This Plan recommends ~~eight distinct zoning districts for the OTC boundary be analyzed. The following recommendations (see Map 6) should~~ be considered during the Region 5 Plan Comprehensive Zoning process. ~~Map 6 illustrates the proposed zoning map. The table below outlines~~ illustrates the evolution of the zoning districts and regulatory blocks from the 2016 Master Plan, to this Plan, and ~~recommended comprehensive zoning changes.~~

This Plan recommends the OTC boundary be analyzed. The following recommendations should be considered during the Region 5 Plan Comprehensive Zoning process. Map 6 illustrates the proposed zoning map. The table below outlines the evolution of the zoning districts and regulatory blocks from the 2016 Master Plan to this Plan.

Zoning Districts

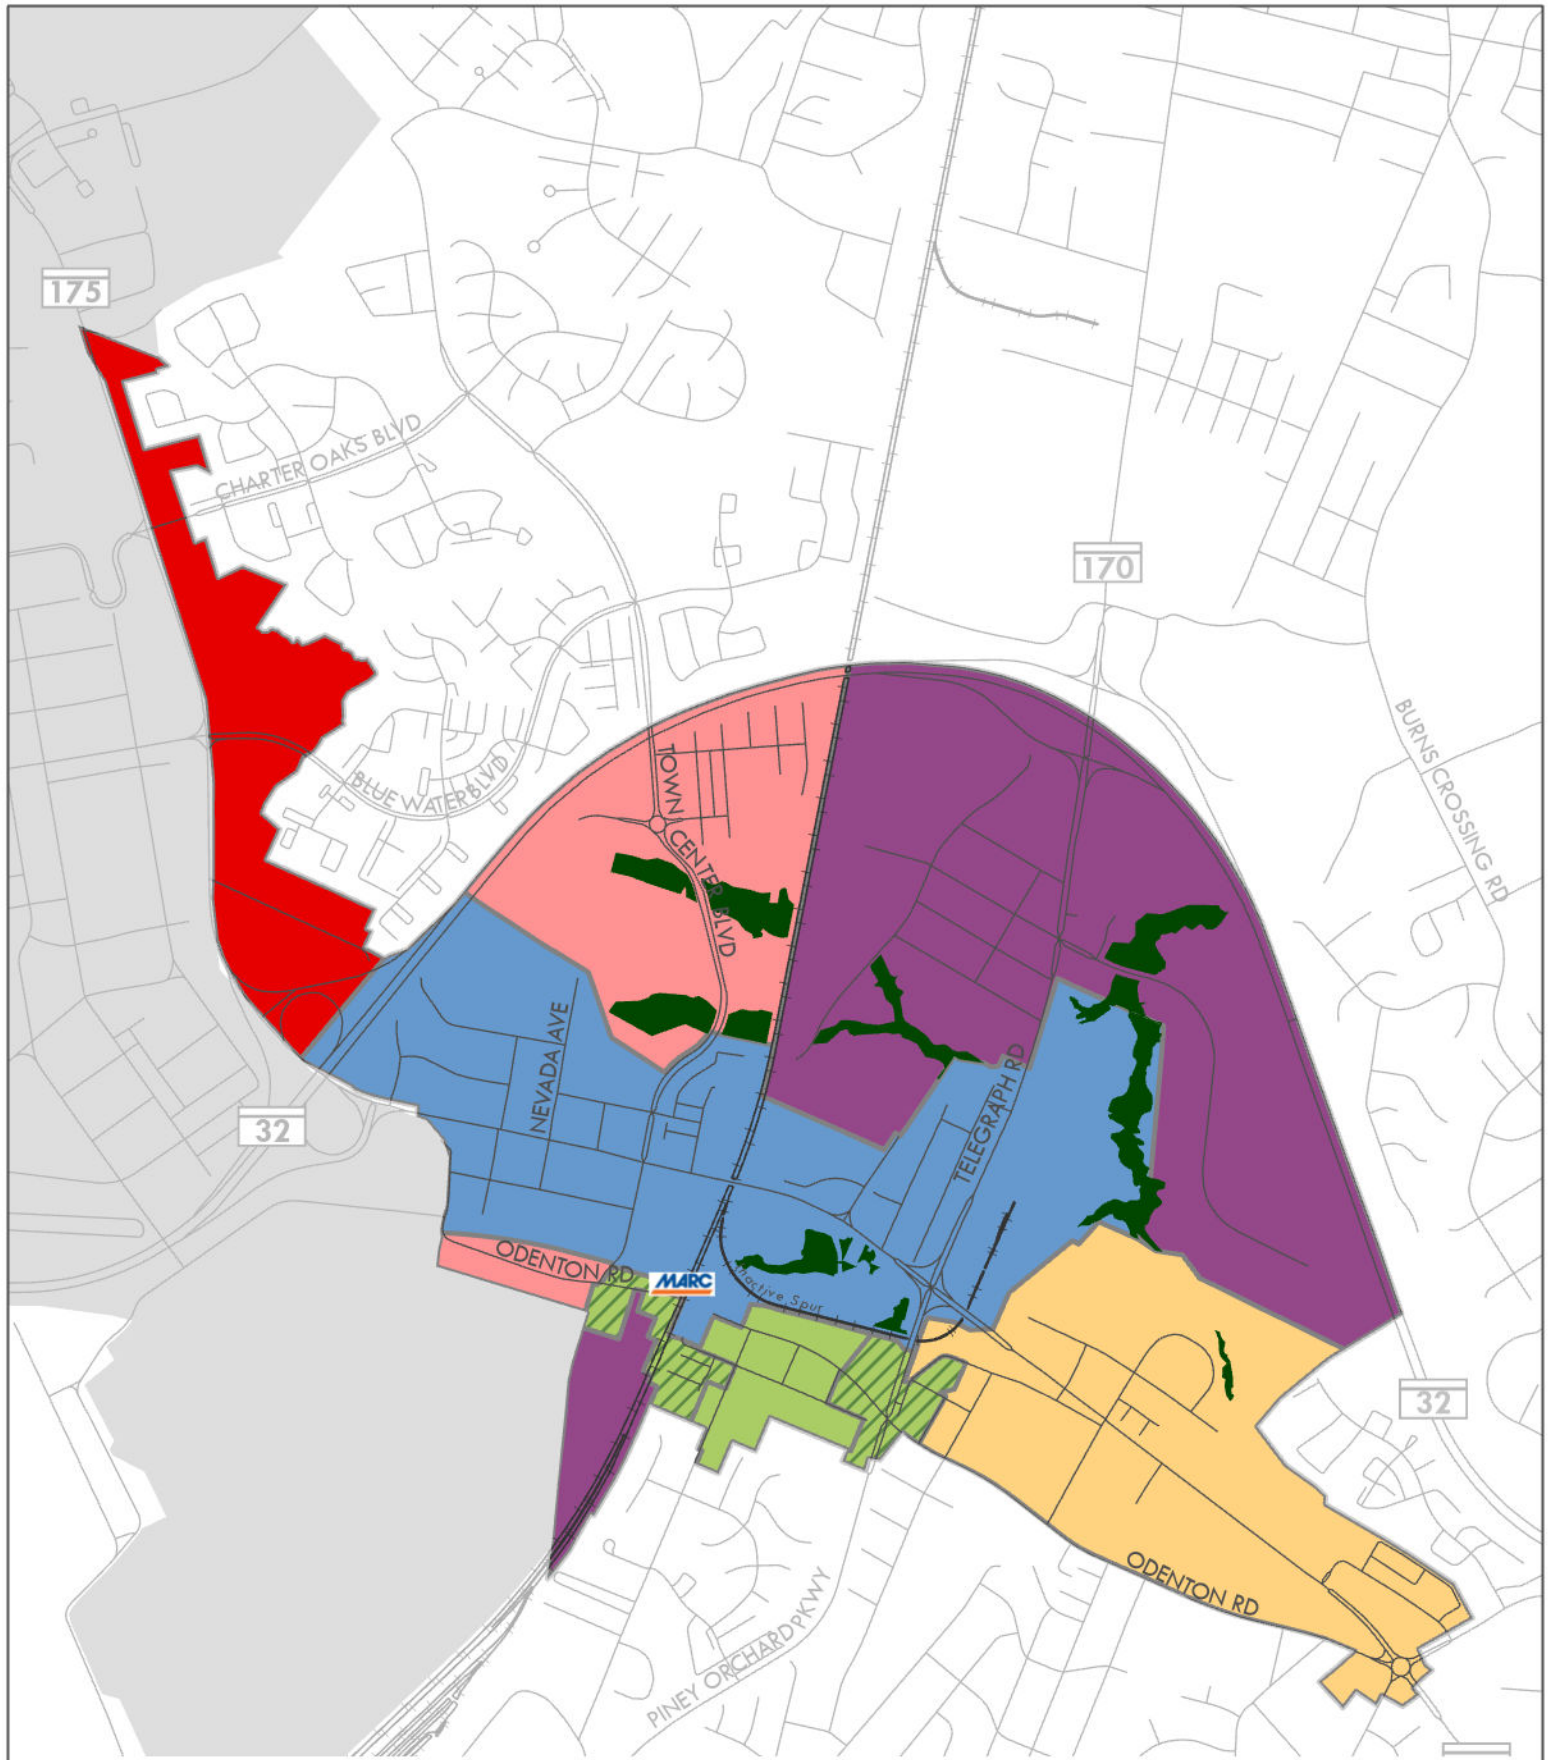
~~The OTC Core (OTC-C) is recommended to be split into two distinct zoning districts to further distinguish between two areas of future development. The West Core (OTC-WC) should continue to be the focus of TOD. The East Core (OTC-EC) is anticipated to support the TOD given that it is separated from the MARC Station by the rail lines, a historic district, and major highways.~~

~~The Historic Village Mix Overlay Block is recommended to become its own Zoning District, named the Historic Village Mix (OTC-HVM).~~

~~It is also recommended that the boundary of the OTC be analyzed.~~

- ~~• The boundary should align with parcel boundaries to avoid split-zoning and consideration should be given to add and/or remove properties based on the vision of this plan. For example:~~

- ~~• Apply Open Space zoning districts based on current County policy~~
- ~~• Add 1046 Annapolis Road (tax account # 400000051510) to the Odenton Town Center at the northeast corner of the Properties adjacent to the Sappington Station roundabout and zone it OTC-E (East Odenton Village Mix), such as commercial properties to the northeast, should be added to the OTC~~

- ~~• Add 1311 Odenton Road (tax account #400003942452) to the Odenton Town Center and zone it Historic Village Mix Overlay Block Properties adjacent to train networks, such as the WB&A Trail along Piney Orchard Parkway, should be added to the OTC~~

- ~~• Properties along the periphery of the OTC that are contiguous with 1 subdivisions outside of the OTC, such as floodplain parcels, should be removed.~~

- ~~• Change the zoning of 1421 and 1423 Odenton Road (tax account #400090019868, 400090233359, 400090233360) from Historic Village Mix Overlay Block to OTC-T (Transition) due to the historic structure no longer on the site. Historic properties should be re-evaluated to determine whether it is appropriate for them to stay within the Historic or Historic Village Mix zoning districts.~~

- ~~• Change the zoning at 1405 Odenton Road to match the subdivision plans. The zoning for the historic single-family house should be Historic Village Mix Overlay Block and the remainder of the property should be OTC- I (Industrial).~~

- The boundary should align with parcel boundaries to avoid split-zoning
- Apply Open Space zoning districts based on current County policy
- Add 1046 Annapolis Road (tax account # 400000051510) to the Odenton Town Center and zone it OTC-E (East Odenton Village Mix)
- Add 1311 Odenton Road (tax account #400003942452) to the Odenton Town Center and zone it Historic Village Mix Overlay Block
- Change the zoning of 1421 and 1423 Odenton Road (tax account #400090019868, 400090233359, 400090233360) from Historic Village Mix Overlay Block to OTC-T (Transition) due to the historic structure no longer on the site
- Change the zoning at 1405 Odenton Road to match the subdivision plans. The zoning for the historic single-family house should be Historic Village Mix Overlay Block and the remainder of the property should be OTC- I (Industrial).
